November 1, 2022

ADDENDUM 2

Walnut Valley Unified School District
Diamond Bar High School
Building 400 Modernization New Classrooms/Library Media
DSA #03-121330 | File #19-H52

S204

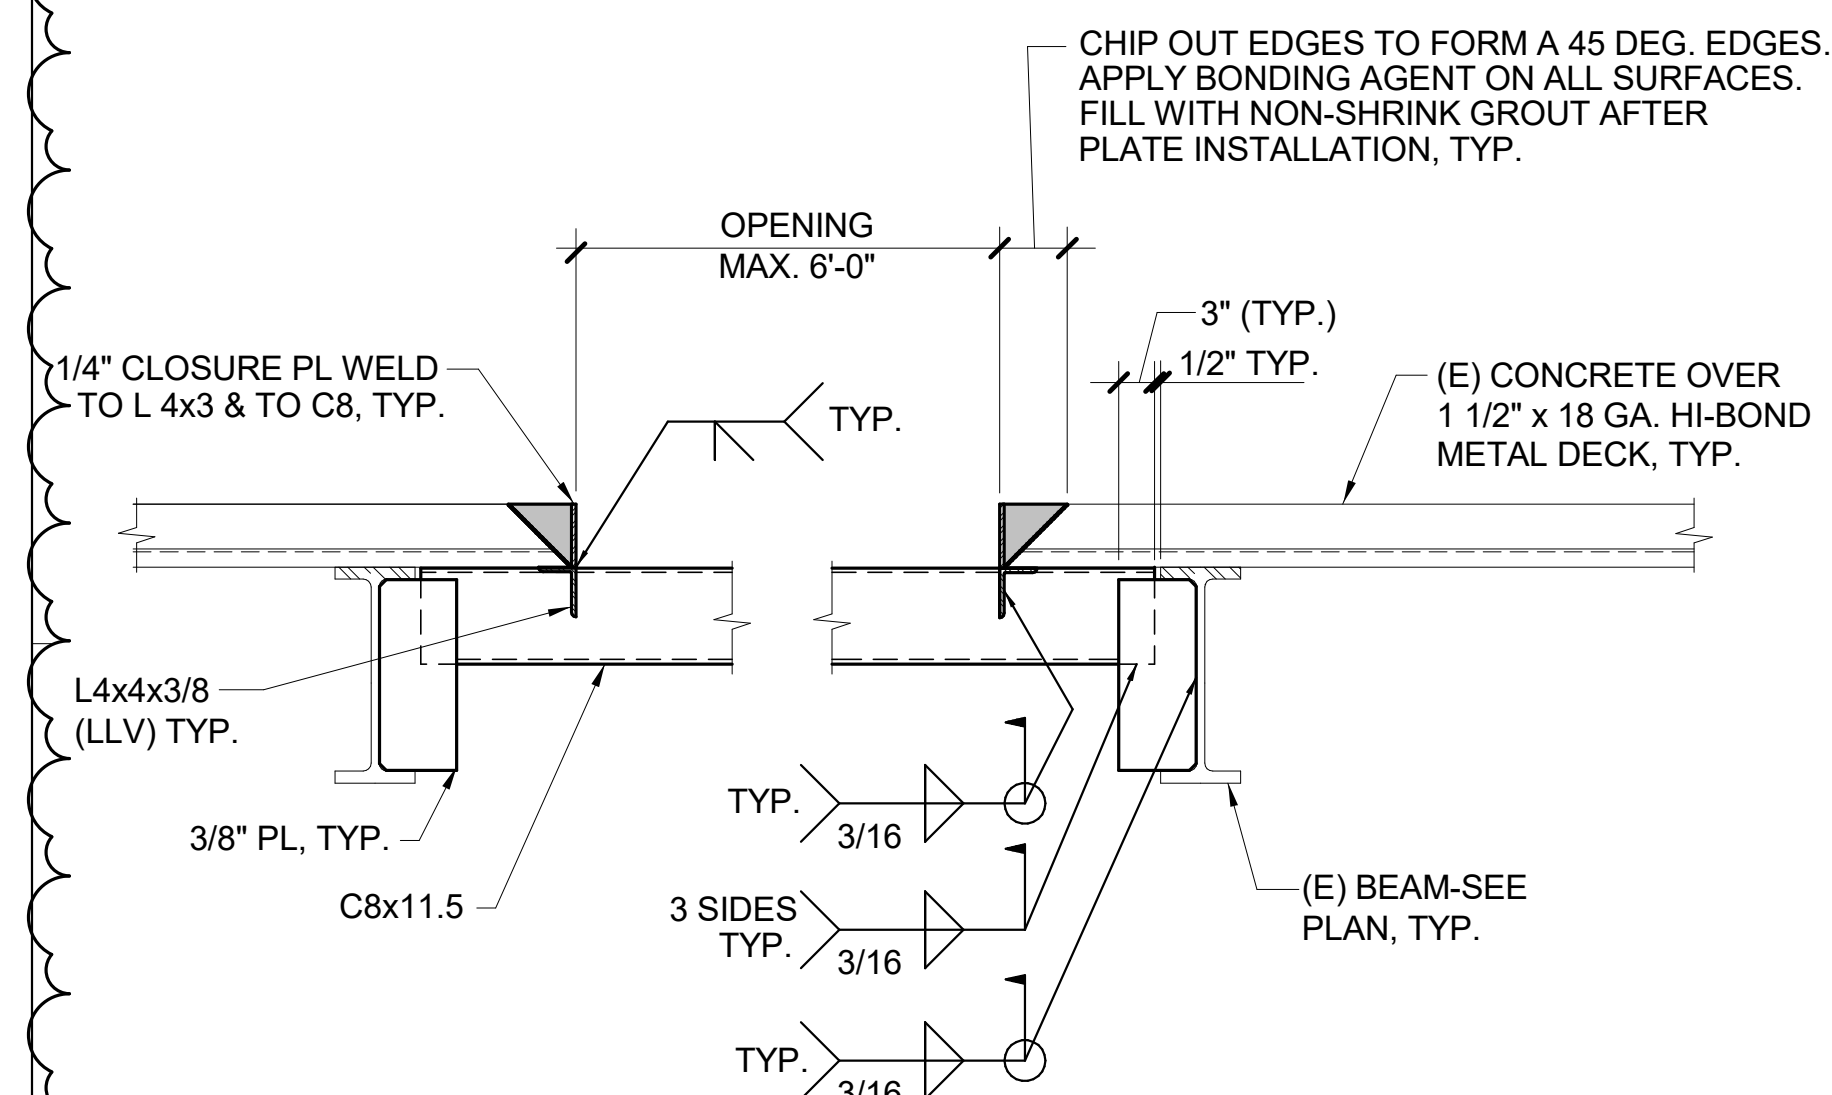
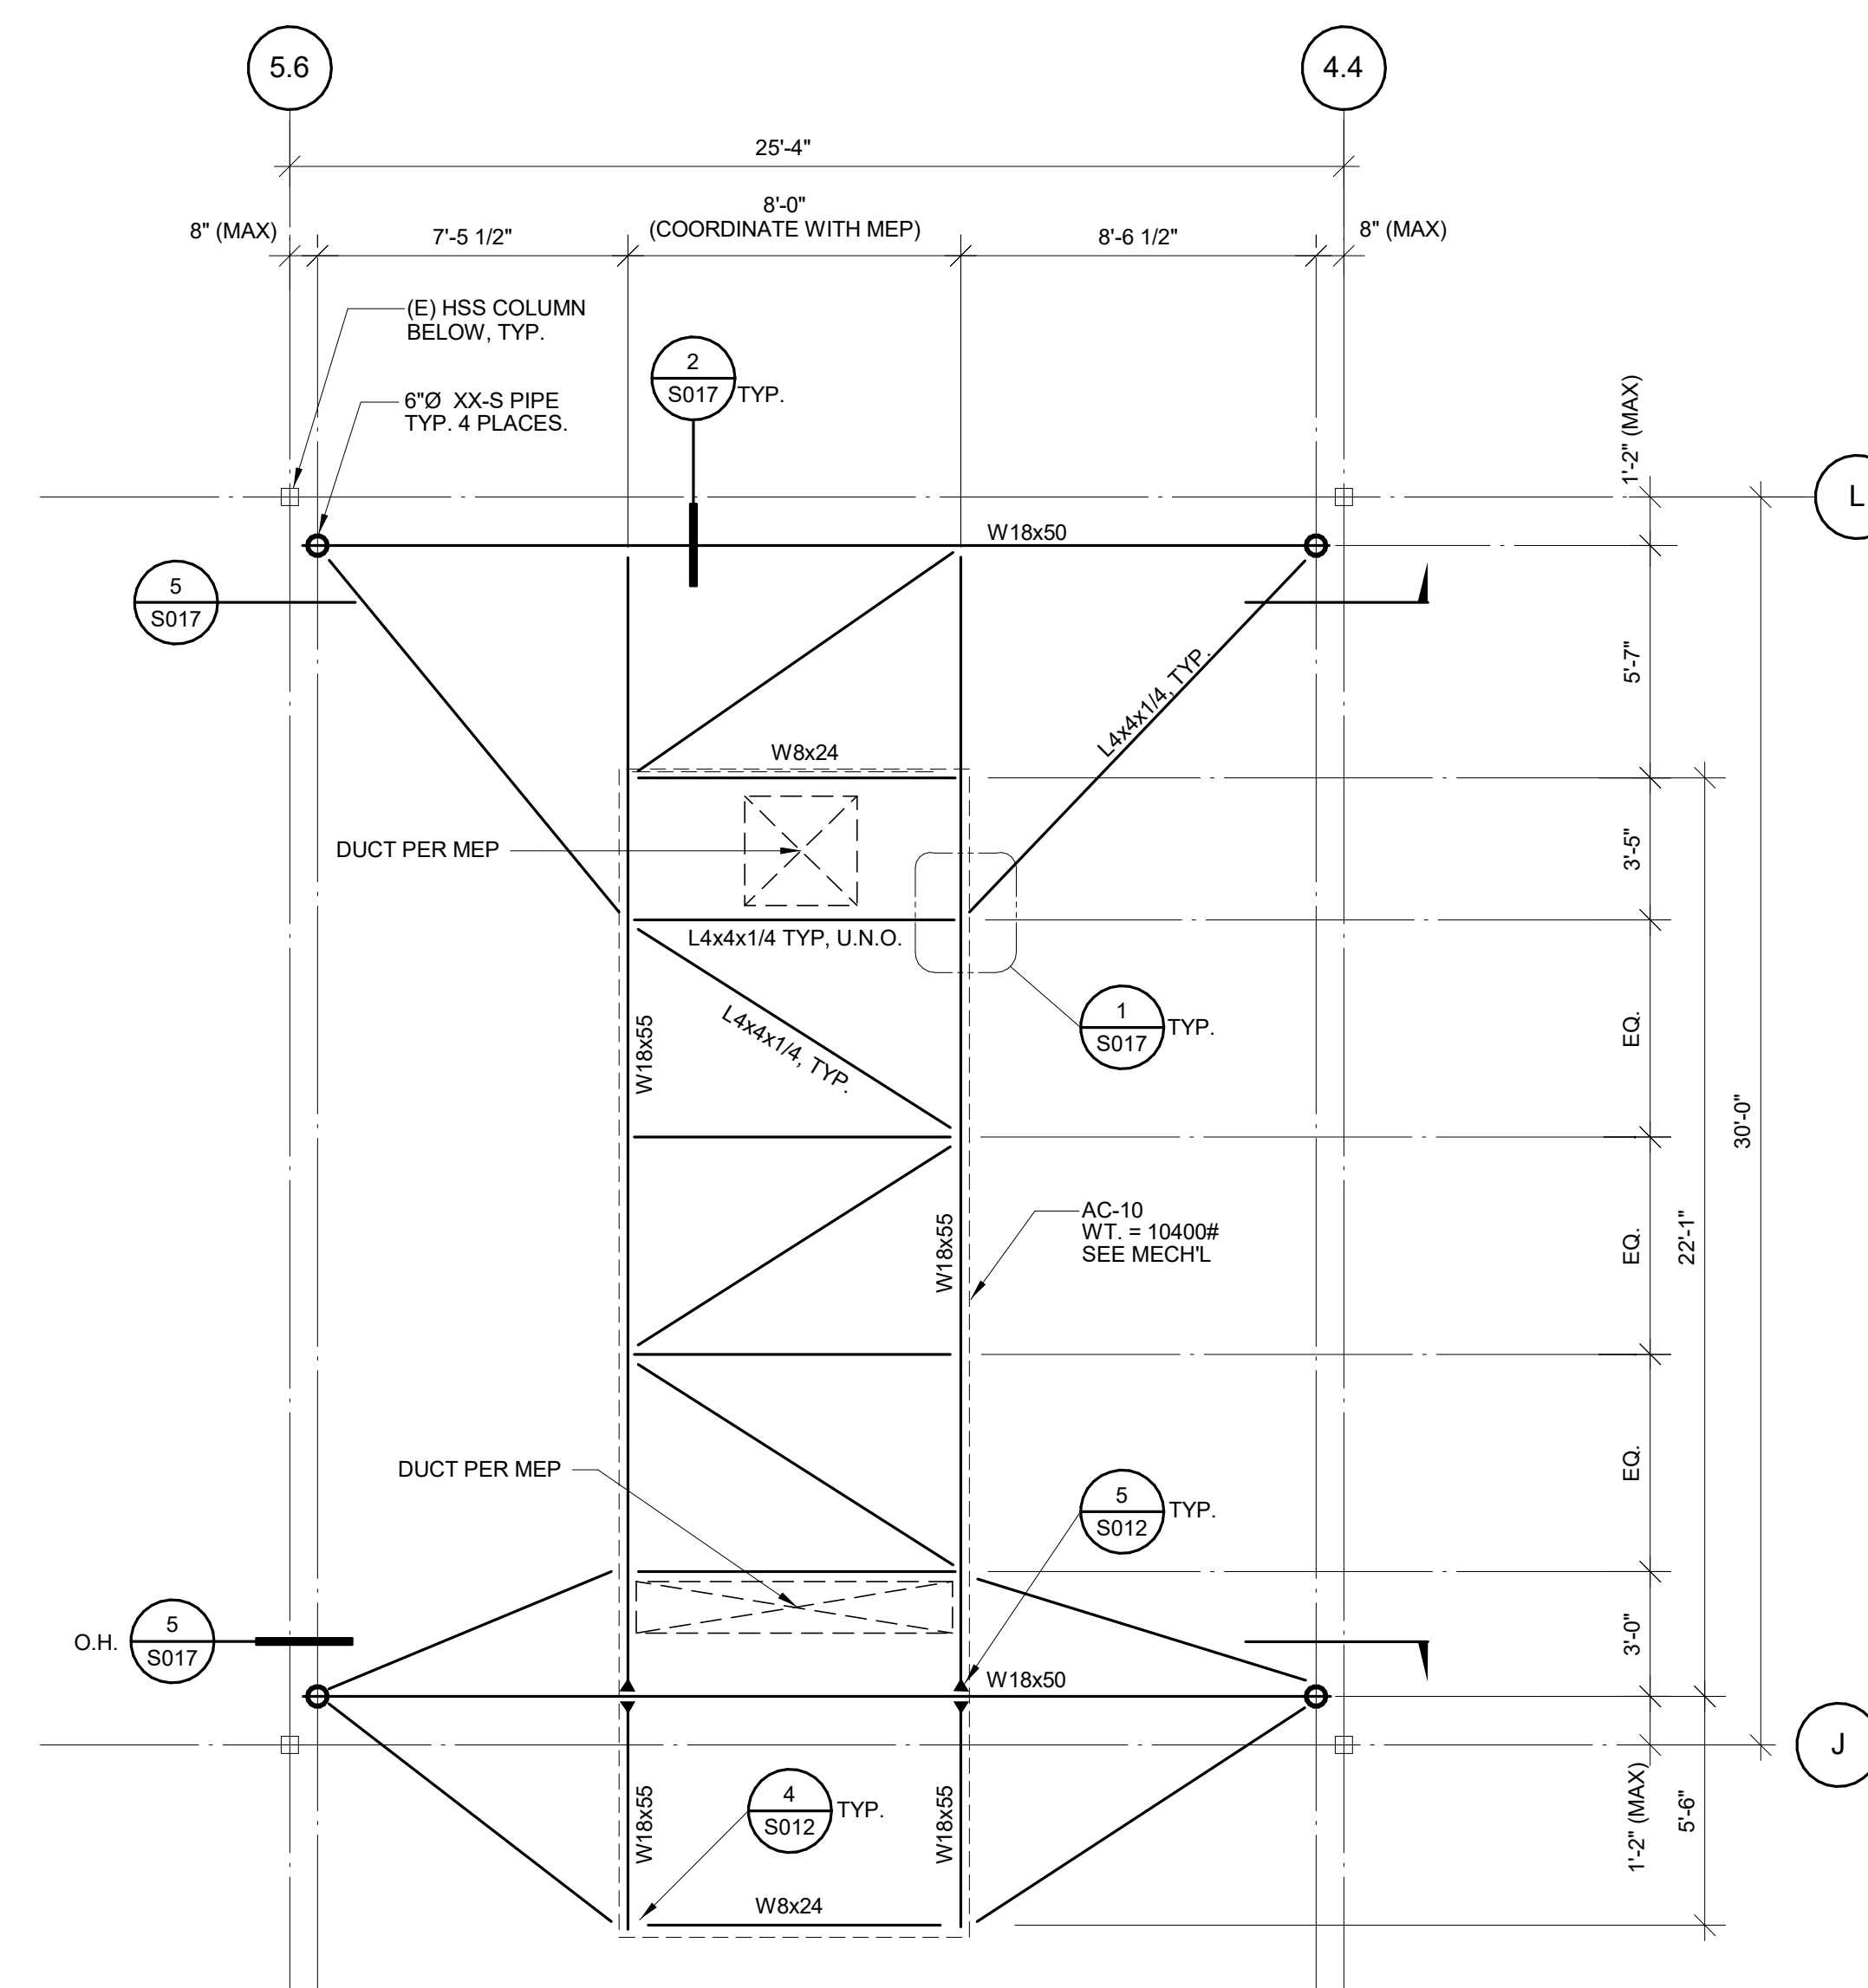
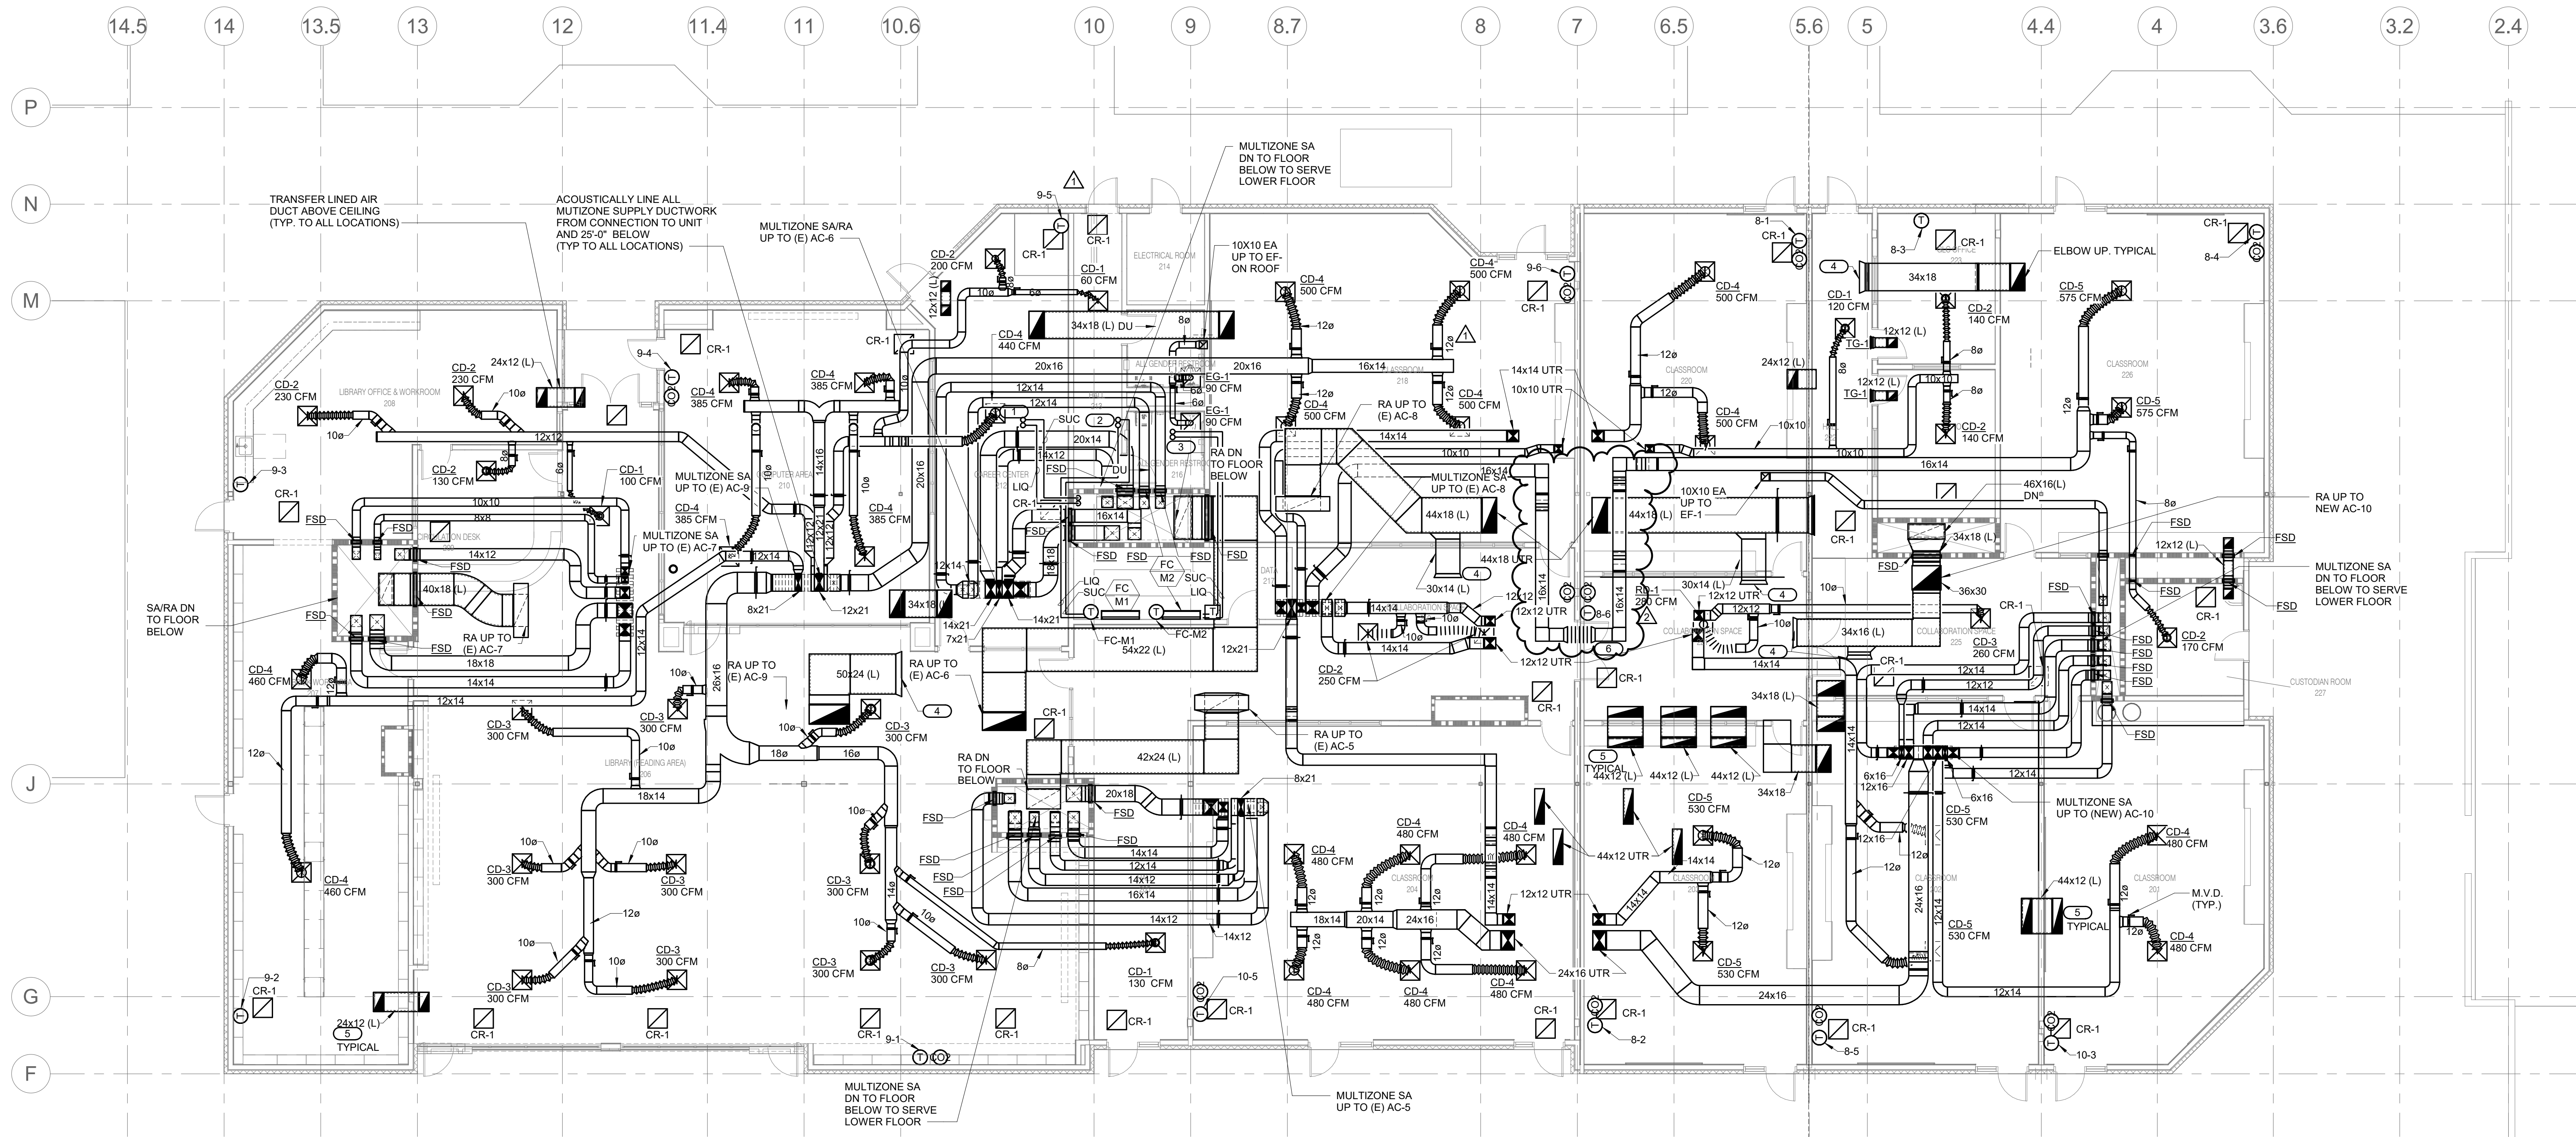
S204 AC-10 SUPPORT FRAMING PLAN AND FLOOR OPENING DETAILS

- A. REVISED DETAILS 3 AND 4.
